CALENDAR ITEM

GENERAL PERMIT -PUBLIC AGENCY USE

LAND USE: Installation and maintenance of Goleta Beach
Slough Revetment.

NEGATIVE DECLARATION: 86-ND-14 REVISED FINAL

Figure 2.
Conceptual Project Plans
Goleta Beach Park Revetment
86-ND-14

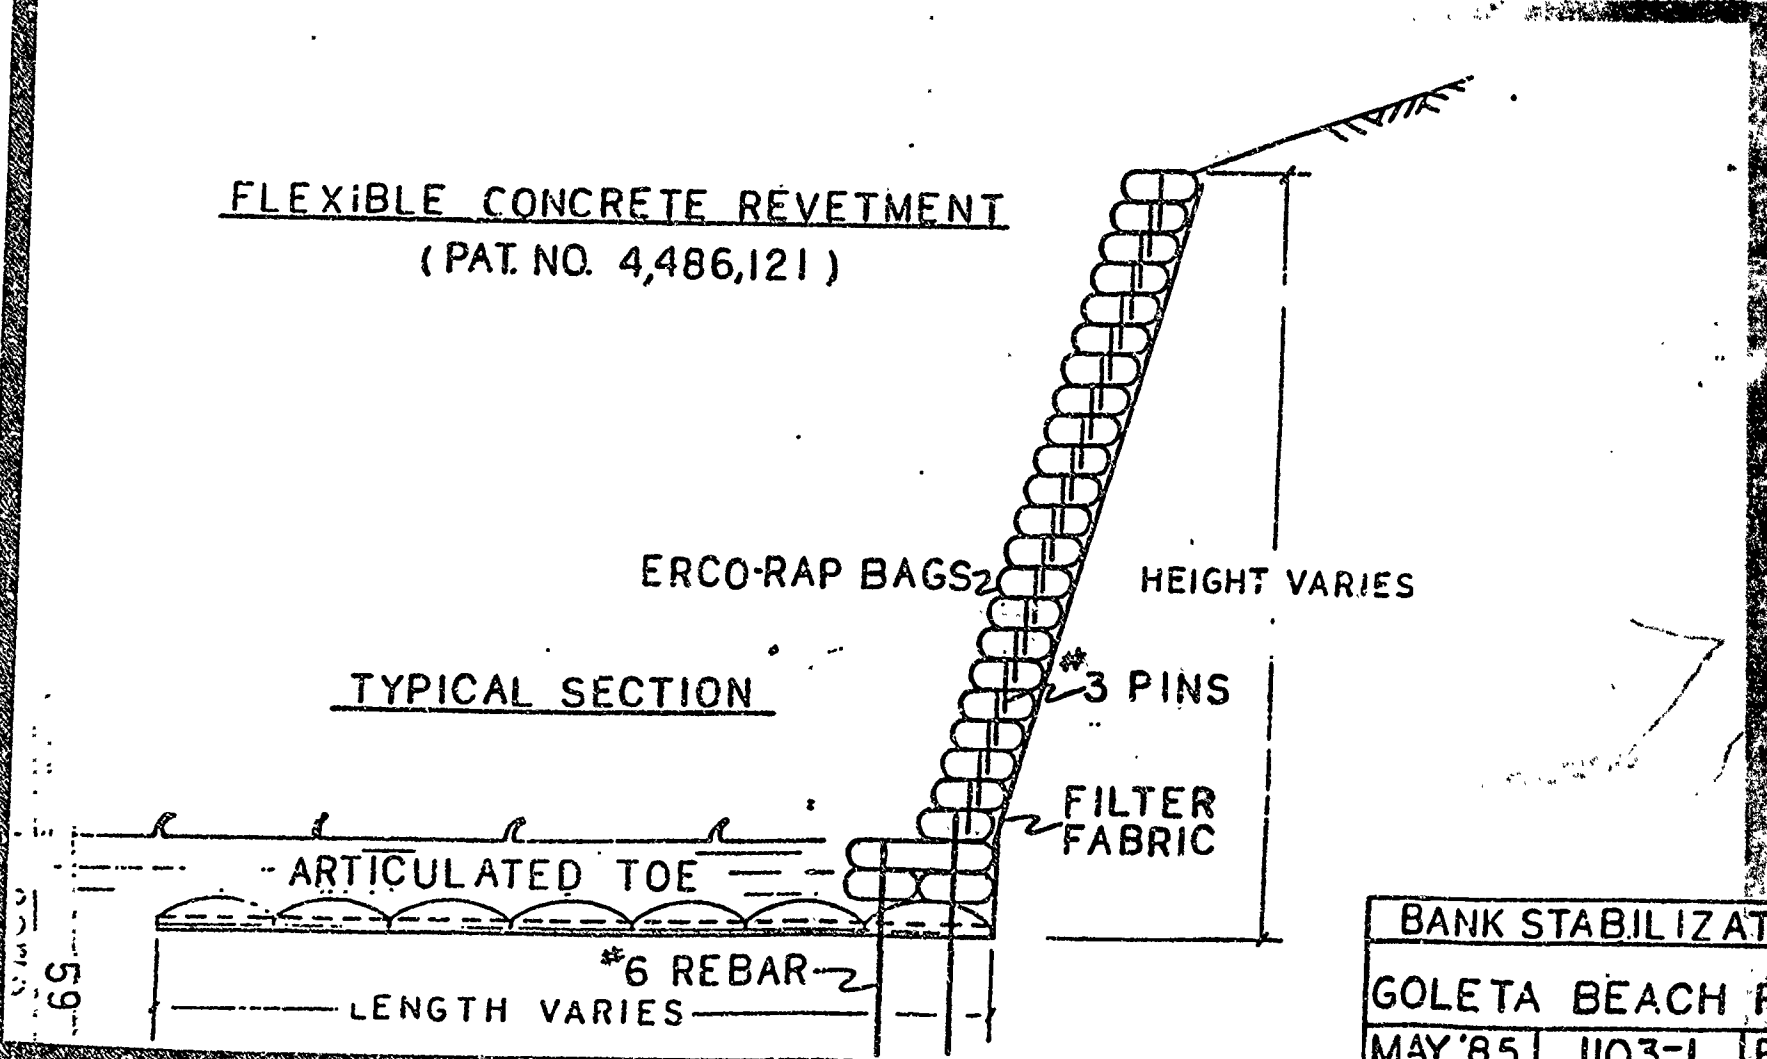
Aesthetics: The revetment is proposed to be constructed of sac-crete, or rows of bags filled with concrete. This type of construction results in a structure which is non-natural in appearance and which may be considered significantly adverse aesthetically. The site can be considered scenic due to its natural features (tidal channel, bluffs, sandy beach, etc.) and the park is visited by approximately 2 million individuals annually (Parks Department). Persons who visit the park to birdwatch, or to fish in the tidal channel or stroll along it would be able to view the proposed revetment. In addition, the site is visible from Sandspit Road and from the Atascadero Creek Bikeway. To avoid significant adverse impacts to the visual quality of the area, the Parks Department has agreed to landscape and color the revetment to blend with the adjacent natural channel banks. With the incorporation of these measures the impacts of the project on the site's visual resources is found to be less than significant, although adverse. To further reduce aesthetic impacts, the use of natural rock rip-rap (rather than sac-crete) is recommended.

As stated, although sac-crete has been considered, a final design decision has not been made. The project site, as it currently exists, cannot be considered aesthetic - there are numerous trees which have fallen into the slough; there are pot holes, exposed pipelines, and large slabs of asphalt in the channel. In many areas, due to the erosion of the bank, this area is currently impracticable for strolling or fishing.
